MRW Project: S12076

May 3, 2012

**Re: Structural Condition Inspection
Algo Centre Mall, Elliot Lake, ON**

**Re: Structural Review the Parking Deck Structure at
Algo Centre Mall, Elliot Lake**

Picture 1: Algo Inn parking deck over mall, lower roof at end in the central boiler room, offices at deck level , three floors of hotel above.

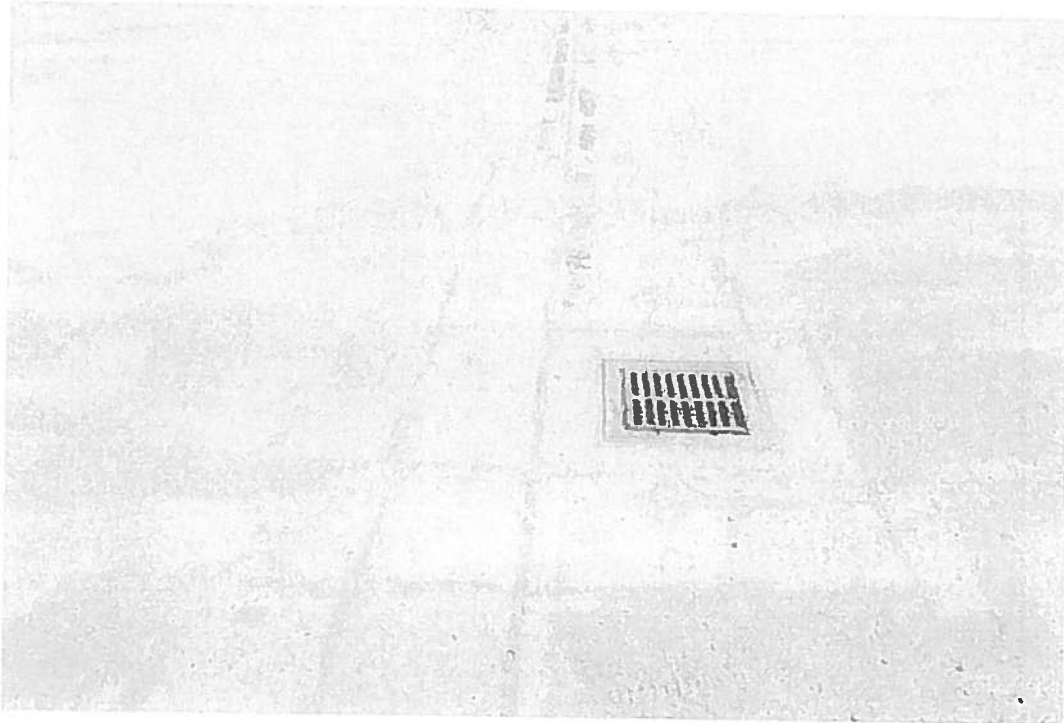
Our inspection revealed evidence of rusting on the structural steel beam members in areas where the parking deck has leaked as shown in Pictures 1 through 8. The area of open walkways shown in Pictures 9 through 12 also have areas with surface rust.

Picture 3: Parking deck sealant in joints and deck drain above area leaks below in Zellers.

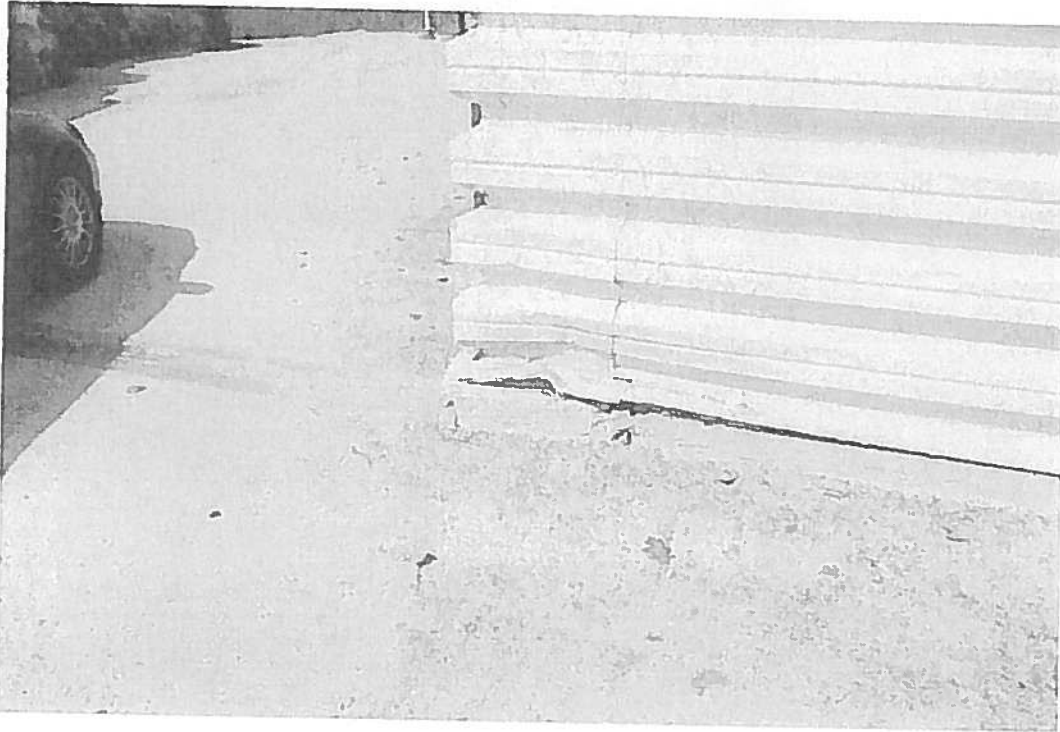
Picture 2: South entry to parking deck above Zellers..

Picture 5: Impact at SW corner of Algo Inn at expansion joint.

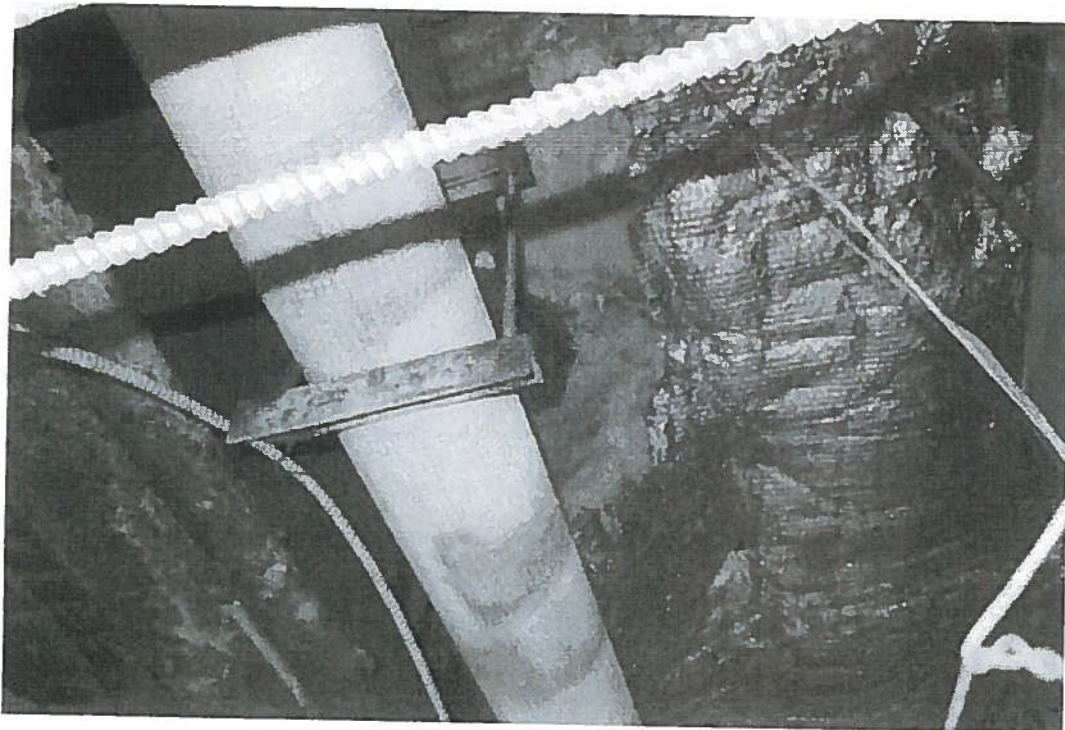
All beams inspected had little loss of section and we would consider the members still structurally sound. The ongoing leakage from the parking deck is of particular concern in the areas of Zellers, and the expansion joint located along the south wall of the Algo Inn, over the municipal library. As per Pictures 5 and 6 we noted vehicular impact on wall siding in this area, that may also have added to the problem.

Picture 4: Major expansion joint at SW corner of Algo Inn. Leakage in Library below.

Picture 6: Expansion joint at SE corner of Algo Inn leaks in lottery ticket booth mall below.

Picture 8: Rusting steel beams and drain pipe below parking deck above Zellers ceiling below Picture 2.

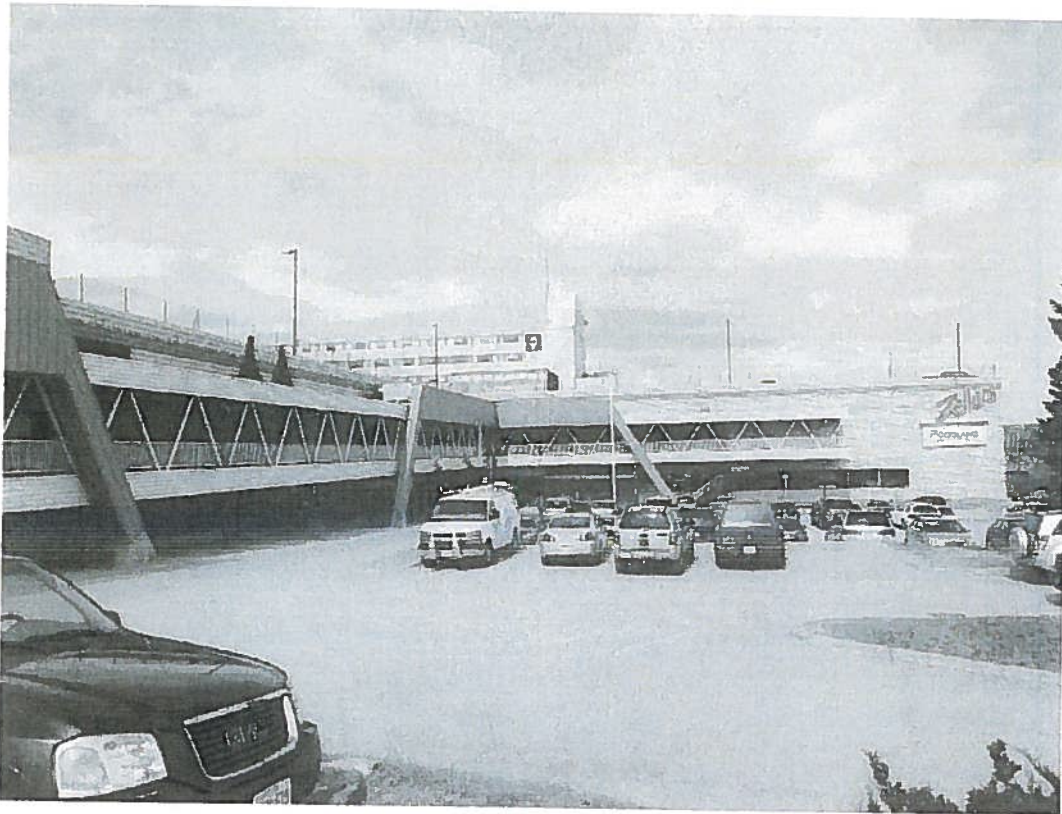
Picture 7: Rusting on steel beams in receiving of Zellers.

Picture 9: East side open walkways of Algo Mall.

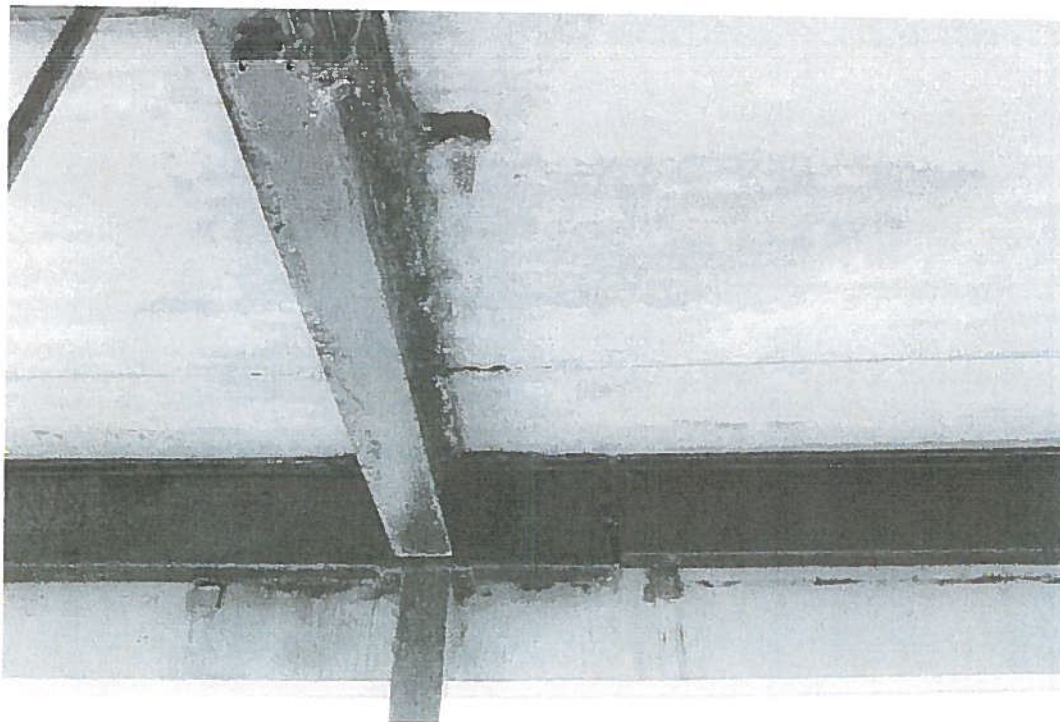
Picture 10: Typical oxidized steel beams underside of deck of open walkways.

Picture 11: Rusting steel at base of diagonal HSS members of open walkway.

Picture 12: Rusting steel U/S of deck of open walkway.

Picture 2: Typical water ponding on Line 5 over steel beam support for precast slabs. Observe black tarred joints every 4 feet.

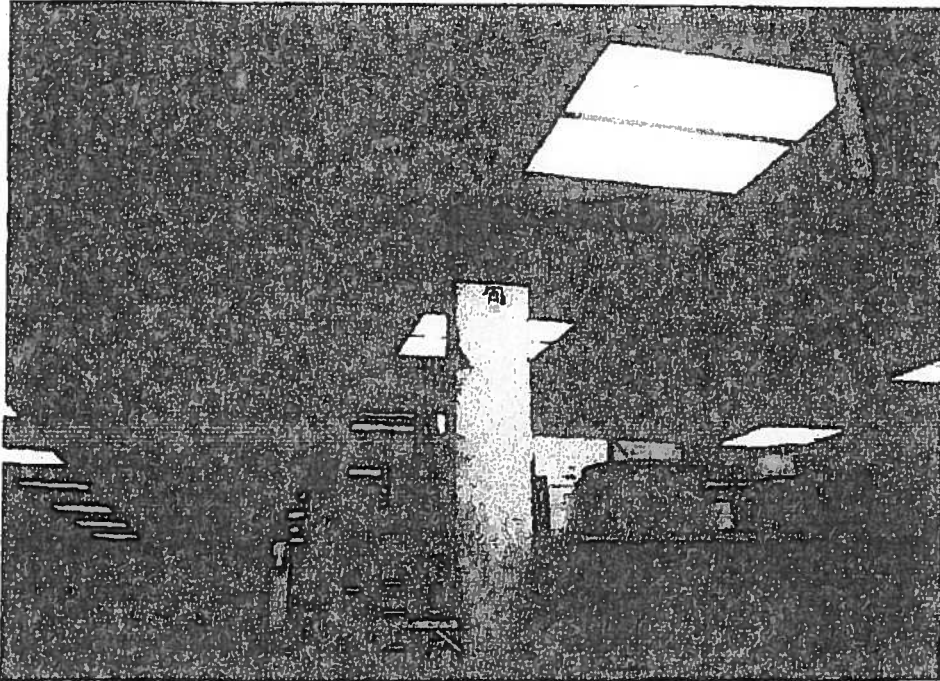
At the time of our inspection the installation of additional caulking and waterproofing repairs were still in progress on the parking deck over the Zellers Store at the south end of the Mall. Inspection revealed that the concrete topping has been saw cut and caulked at 4 foot intervals north to south and along each beam location on grid lines. Efforts over the years appear to have attempted to waterproof the mall utilizing the concrete topping and the noted caulked joints located over joints in the precast slabs with no waterproofing membrane, See Pictures 1 and 2.

Picture 3: Line 5 in Zellers below water ponding in Picture 2. Top shelf brown storage bin right of column collects water, half full at time of inspection.

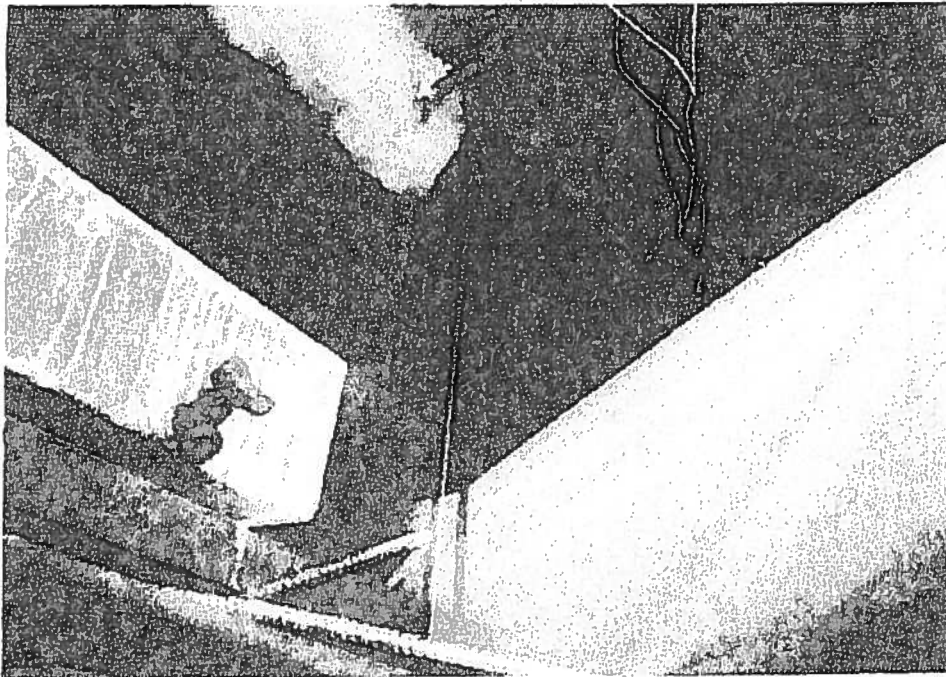
The structural steel is not fire-rated throughout Zellers. The primer painted structural steel has surface rusting, but in all areas inspected no loss of steel section was observed.

Picture 4: Yellow tarp and galvanized eavestrough with faucet to collect water penetration through slab steel not fire-rated in Zellers. Only surface rusting on beams.
